Product Change Notification

PRECISION POTENTIOMETERS

August, 2009

Model 3590 Additional Upgrades

Blue Valox Shaft

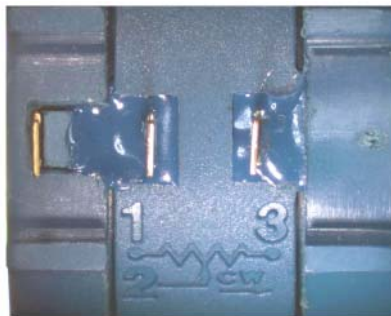
The blue plastic material used to mold plastic shafts and rotors will be changed from **blue** Valox to **black** Nylon 6/6. The change in materials will eliminate the use of Teflon washers. Implementation for this change started with date code 0930M.

Rear Terminal with Insert

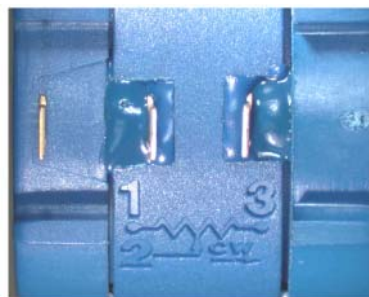
The rear cover design is being upgraded to a molded-in terminal design. This will eliminate the insert and epoxy for the rear terminal. This change is scheduled for implementation starting with date code 0934M.
